Docket Item #12-B
Development Special Use Permit #2011-0002
Braddock Gateway – Phase I – 1219 First Street

DSUP #2011-0002
Braddock Gateway
CDD #15 - Phase I
1219 First St.

**CDD CONCEPT
PLAN# 2011-0003
DSUP# 2011-0002**

SOUTH ELEVATION
5/27/10

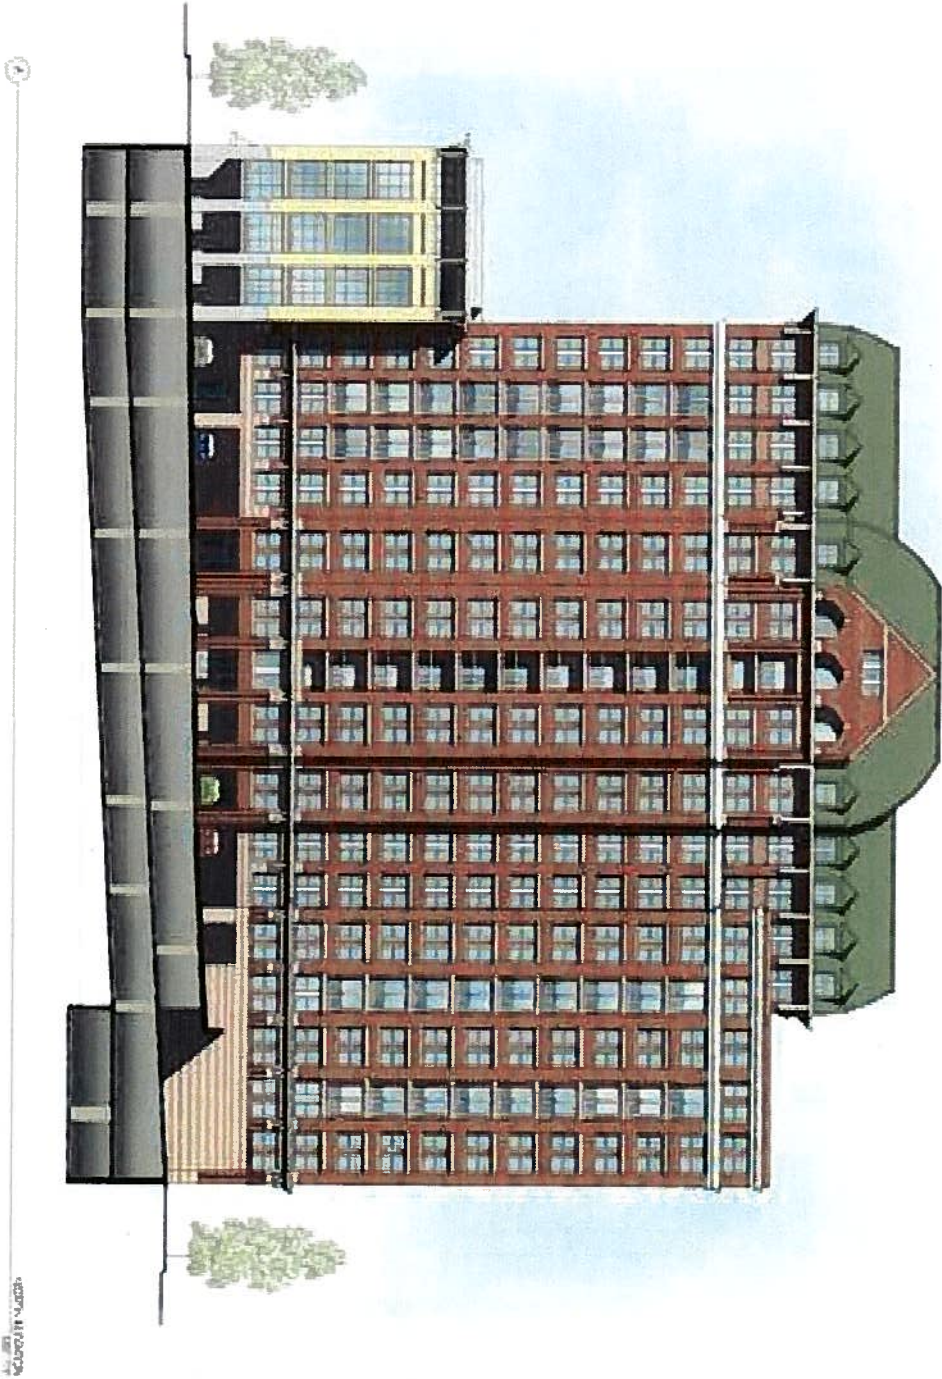
With the first DSUP application, the first phase's building design (the southernmost building in the development) is being revisited in an effort to enhance the original design. As the applicant has presented to Planning staff in recent meetings, the intent has been to keep the original design intact, while making a few adjustments to massing that would, in staff's opinion, improve the overall scale and character of the building. While keeping most of the building facades and details essentially unchanged, the tall west wing of the structure has now been lowered, creating a building "shoulder" along North Payne Street, which accomplishes a number of desirable objectives. First, it carves away the more monolithic mass as previously proposed, to reveal a central "tower" element, that reinforces the designs of the proposed buildings to the north. Second, the addition of a building "shoulder" is in keeping with the overall urban design intent of the Braddock Metro Neighborhood Plan, particularly as North Payne Street is a relatively small-scale street, which will benefit from this sort of scale transition. Finally, the massing change does this without taking away from the approved architectural character of the building. There are some façade revisions being proposed along with this change, such as the

simplification of some of the cornice treatments, in order to make the central tower element more prominent and bringing the glass at the building entrance more to the foreground. Staff feels that these changes are entirely in keeping with the spirit of the CDD approval, and can be handled administratively as the detailed design progresses through final site plan and building permit.

A key element in staff's recommendation to proceed with the design as amended is that the project will retain both its design character, the high quality of materials and detailing that was approved in the original CDD. As such, staff is recommending that the Planning Commission and City Council approve the building design as submitted in the DSUP, with the understanding that refinements may take place during the final site plan process.
